# **CONNECTION ASSESSMENT & APPROVAL PROCESS ASSESSMENT SUMMARY**

**Applicant: Hydro One Networks Inc.**

**Project: Richview TS – Replace 230kV Line  
Disconnect Switch V71R and Breaker  
Disconnect Switch L12L19-12**

**CAA ID: 2002 – EX086**

**Figure 1: Richview TS – L12L19 Diameter**

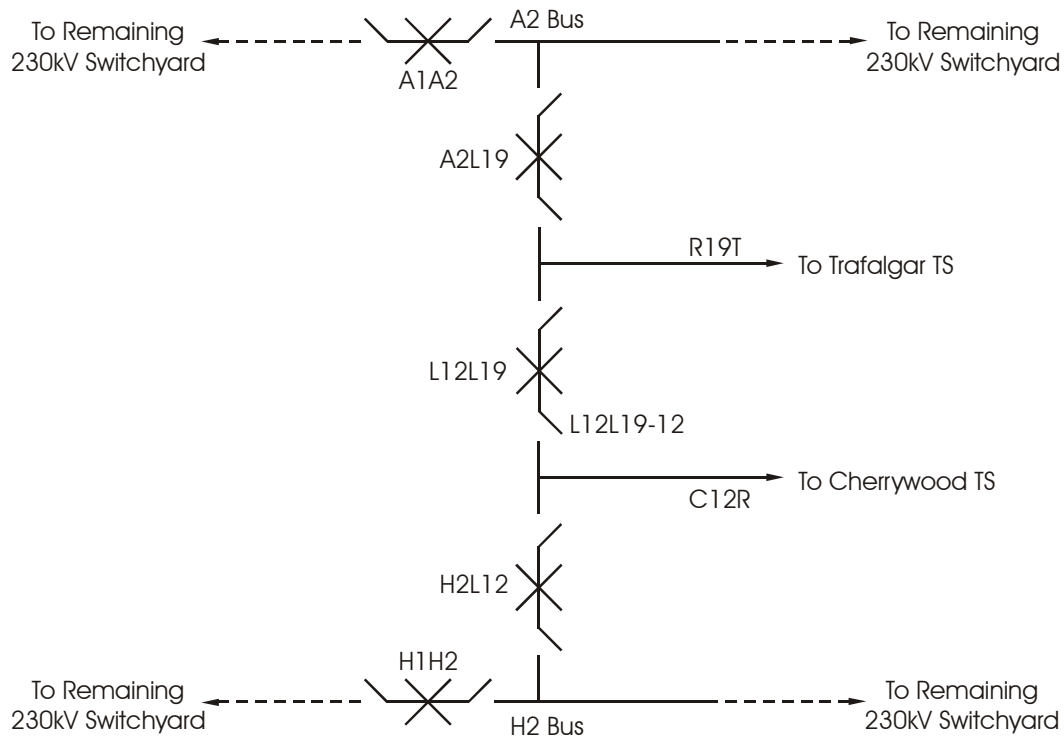
The Richview TS 230kV switchyard has a three-breaker diameter station arrangement (Breaker and half scheme). As shown in Figure 1, 230kV circuit breaker L12L19 together with breakers A2L19 and H2L12 form a diameter that terminates the Richview TS to Trafalgar TS circuit R19T and the Richview TS to Cherrywood TS circuit C12R. With the existing station arrangement, the breaker disconnect switch L12L19-12, when either breaker A2L19 or H2L12 is out of service, will carry the full load of either circuit R19T or circuit C12R. The breaker disconnect switch L12L19-12 must therefore match the ratings of the circuits R19T and C12R.

The proposed new line disconnect switch has a momentary current rating of 120kA and a short duration rating of 75kA, while the proposed new breaker disconnect switch has lower momentary and short duration ratings of 100kA and 63kA. The applicant shall install a new breaker disconnect switch that can withstand up to 70kA symmetrical short circuit current.

Based on the above assessment, it is recommended that a Notification of Approval for this proposal be issued to the applicant, subject to meeting the requirement that all the new replacement disconnect switches be capable of withstanding a maximum symmetrical fault level of 70kA.
